SERIAL 008, 895

U.S. Patent Aug. 11, 1987 Sheet 6 of 6 4,685,698

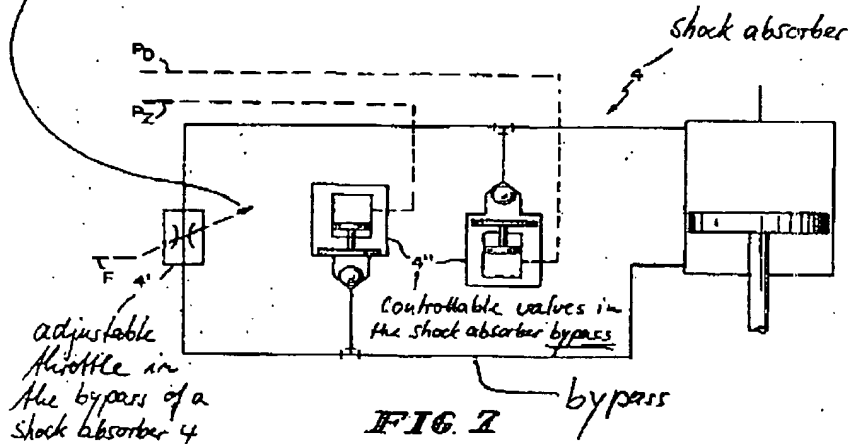
*This arrow in hydraulic elements always indicates that the element is adjustable, thus also completely closeable, and not having a non-varying constricted flow cross-section!*

- 1) On page 2 of the Office Action of 27.01.2005 the examiner states that 4' in Fig. 7 of Klinkner designates a fixed bypass valve with a non-varying constricted flow cross-section. In column 7, line 13 of Klinkner it is clearly stated that 4' designates an adjustable throttle 4' in the bypass of a shock absorber. Thus, it is clear that the examiner is in error.
- 2) Fig. 7 of Klinkner clearly shows an adjustable and controllable bypass of a shock absorber. There is no fixed bypass ~~with~~ having a non-varying constricted flow cross-section.
- 3) Values 4'' are located in the bypass, see Fig. 7 and column 7, line 9 ~~to~~ to line 18. In our invention, the flow regulating systems for the compression and decompression phase which provide continuous damping by having continuous flow resistance are not located in a bypass, but in the main flow path through piston 3!
